# SERVICE BULLETIN

SB No. 153 Issue No. 1

**TITLE** SAB UNDERCARRIAGE NOSEWHEEL FORK INSPECTION

Pre Mod M468 (Introduction of Fairey Undercarriage): T67B, T67C Series, T67M, T67M-MkII and T67M200.

FIG 1

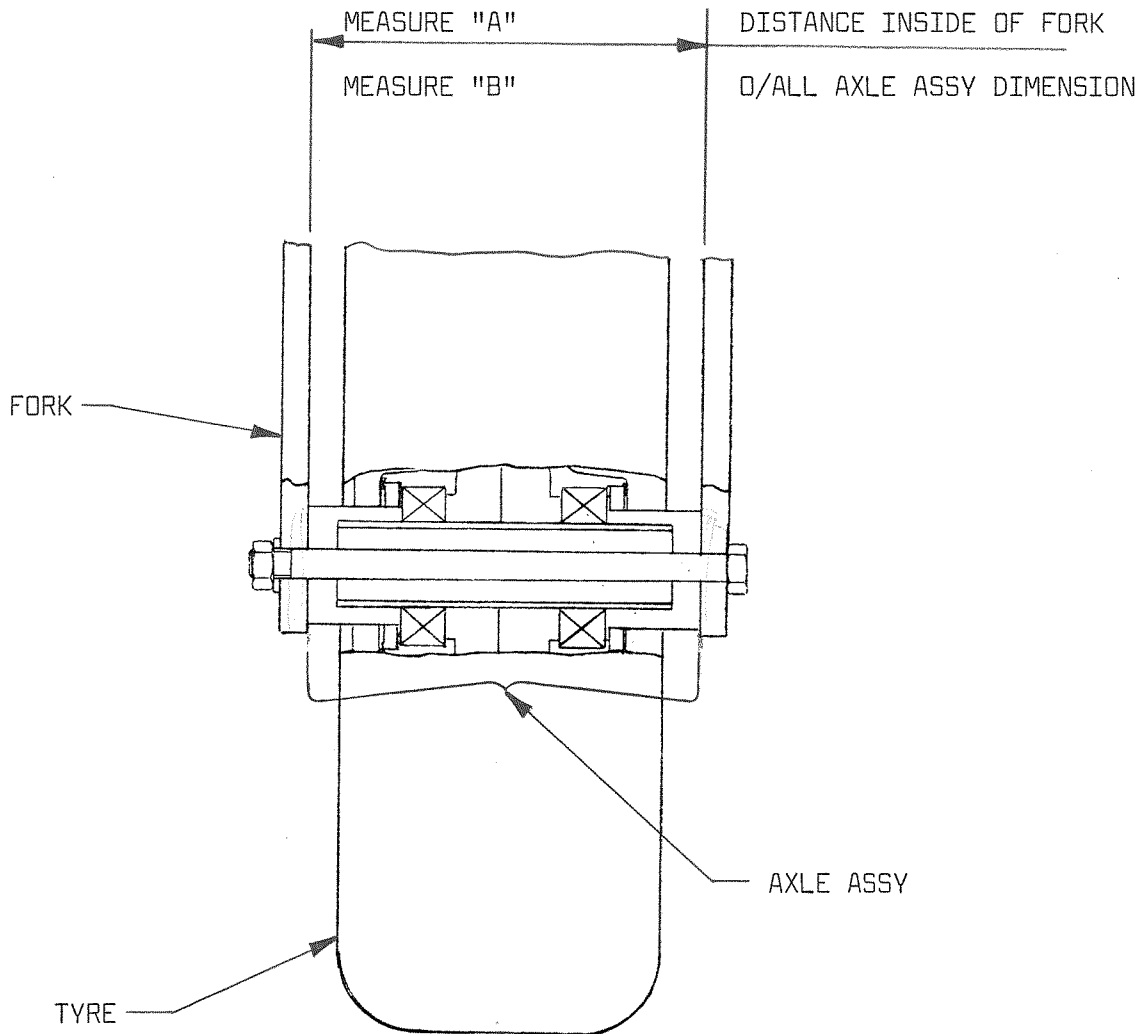
Cases have been reported of the space between the SAB nose undercarriage forks and the wheel axle being sufficiently wide to cause the forks to bend inwards when tight and ultimately cause the axle nut to loosen. This SB requires a one time inspection to determine the width of the gap and fitting of corrective spacers if applicable.

1. Check master switch, ignition switch and fuel are off. Disconnect external power and hangar aircraft, as applicable.
2. Jack or hoist aircraft to bring nosewheel clear of ground with oleo pneumatic strut fully extended
3. Place a suitable trestle support under bottom centre of fuselage 12 inches behind firewall.
4. Remove wheel stiffnut, withdraw axle bolt from axle fork and remove wheel assembly.
5. Leave wheel assembly together and clean outer surfaces of axle spacers and inner surfaces of nosewheel forks.
6. Determine by measurement at axle centreline, the following dimensions, ref Fig. 1.
  - a. Measurement A: The distance between the inner faces of the nosewheel forks. Fork ideally should be parallel.
  - b. Measurement B: The dimension between the axle spacer outer faces when wheel assembly is pushed together, as on aircraft.

7.
  - i. If the difference between the two dimensions is less than 1.5mm, then no further action need be taken.
  - ii. If the difference between the two dimensions is 1.5mm to 4.0mm, then Mod M832 is to be incorporated.
  - iii. If the gap is more than 4.0mm, then new fork is to be procured.
8. Annotate Logbook "SB 153" complied with".
